Access Compliance Report

Public Rights-of-Way

(Curb Ramps)

Intersection ID: 52551	Main Street: KRISTENS_MARE_DR	Cross Street: ARDREY_WOODS_DR	Location:	N
ADA ID: 4D08977847B1	Ramp Type: PerpDiag	Initial Pass/Fail: Fail	Overall Compliance: No	Severity Score: 1.25
Codes/Mitigation Info/Possible Solution		Field Measurements/Component Compliance

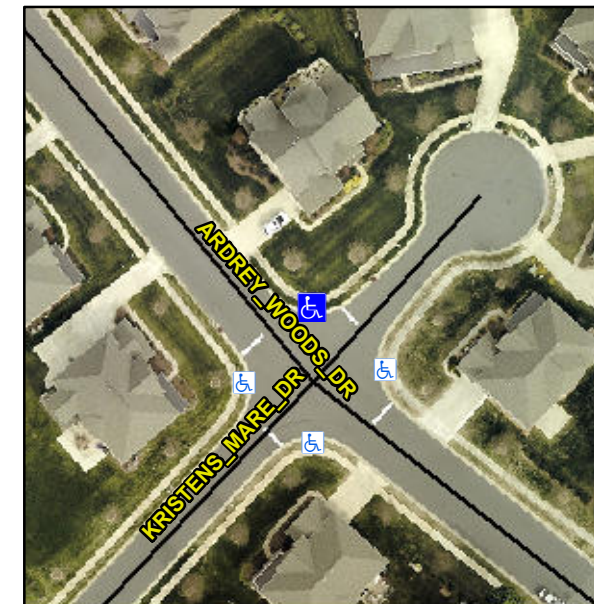
Not Found, R304.5.3

Compliance	Description	Data	Compliance	Description	Data
N/A	Ramp Length (in)	48.0	Yes	Ramp Slope (%)	7.0
Yes	Ramp Width (in)	48.0	No	Ramp XSlope (%)	3.2
N/A	Flare Type LT	N/A	N/A	Flare Type RT	N/A
N/A	Flare Slope LT (%)	N/A	N/A	Flare Slope RT (%)	N/A
N/A	Flare Traversable LT?	N/A	N/A	Flare Traversable RT?	N/A
N/A	Landing Length (in)	N/A	N/A	DWS Provided?	N/A
N/A	Landing Width (in)	N/A	N/A	DWS Contrast?	N/A
N/A	Landing Slope (%)	N/A	N/A	DWS Length (in)	N/A
N/A	Landing X Slope (%)	N/A	N/A	DWS Full Width?	N/A
N/A	Landing Curb? (Y/N)	N/A	N/A	DWS Offset (in)	N/A
N/A	Shared Landing?	N/A			
N/A	Gutter Ponding?	N/A	N/A	Gutter Slope (%)	N/A
N/A	Gutter Lip Ht (in)	N/A	N/A	Gutter X Slope (%)	N/A
N/A	Painted X Walk1?	No	N/A	Painted X Walk2?	No
	X Walk 1 Direction	To SW		X Walk 2 Direction	To SE
N/A	X Walk 1 Width (in)	N/A	N/A	X Walk 2 Width (in)	N/A
	X Walk 1 Slope (%)	2.6		X Walk 2 Slope (%)	3.0
	X Walk 1 X Slope (%)	1.8		X Walk 2 X Slope (%)	2.7

Remove & Replace Curb Ramp With Two New Directional Ramps or Equivalent.
